Re: CALICO - SES SOLAR ONE PROJECT (08-AFC-13)
CURE Data Requests, Set 4 (Nos. 378-402)

**SES Solar One Power Plant
CUREs Data Requests, Set Four (No. 378-402)**

Background: ENVIRONMENTAL IMPACTS ASSOCIATED WITH THE LUGO-PISGAH NO. 2 500KV TRANSMISSION LINE AND PISGAH SUBSTATION EXPANSION

Figure 1. Documented Mohave ground squirrel occurrences in the vicinity of the Project area. Numbers with flags correspond to CNDDDB occurrence numbers.

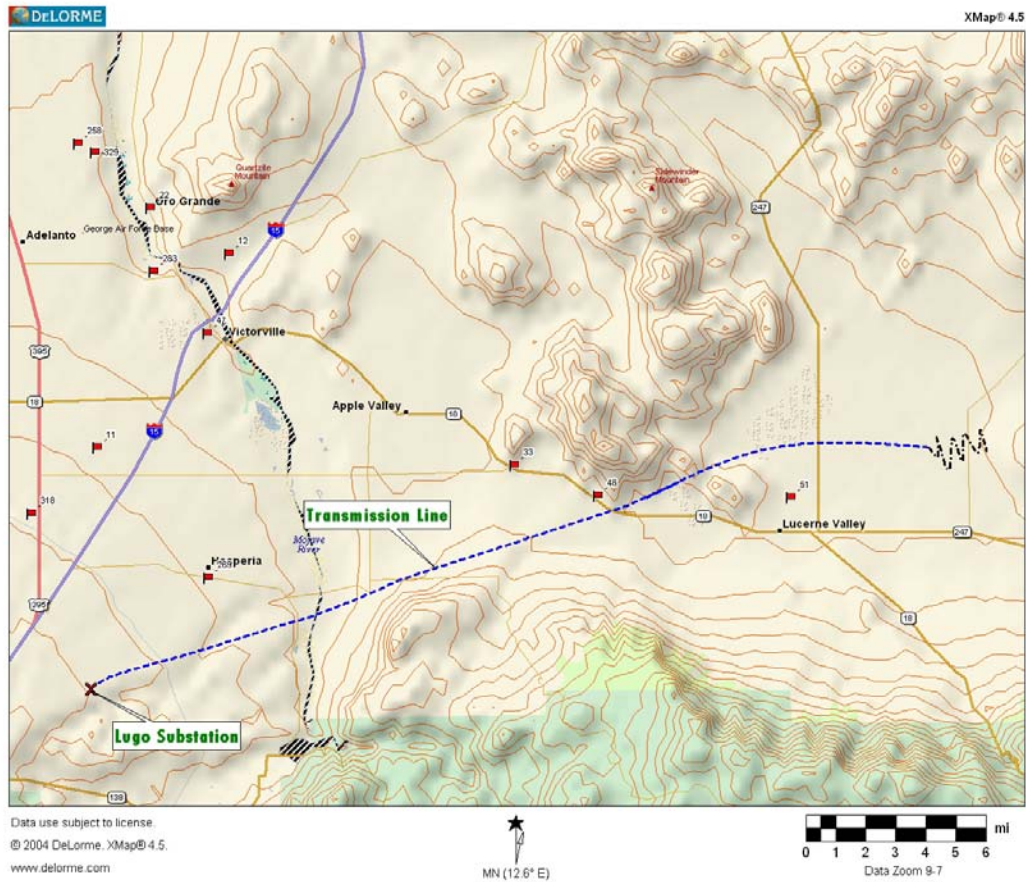
The report states “[t]he closest documented location of the Mojave ground squirrel is greater than five miles from the project area which precludes the requirement for protocol surveys for this species.”¹¹ The CNDDDB has several records of Mohave ground squirrel occurrence within 5 miles of the Project area (Figure 1). Although the records are relatively old, the Mohave ground squirrel is presumed extant at these locations.¹²

- 388. Please clarify the report’s statement that the closest documented occurrence of Mohave ground squirrel is greater than 5 miles from the Project area.
- 389. Please provide a copy of the CDFG guidance that waives the requirement for protocol surveys for projects greater than 5 miles from documented Mohave ground squirrel locations.
- 390. Please clarify the need to conduct surveys for the Mohave ground squirrel in the area covered by the West Mojave Plan.
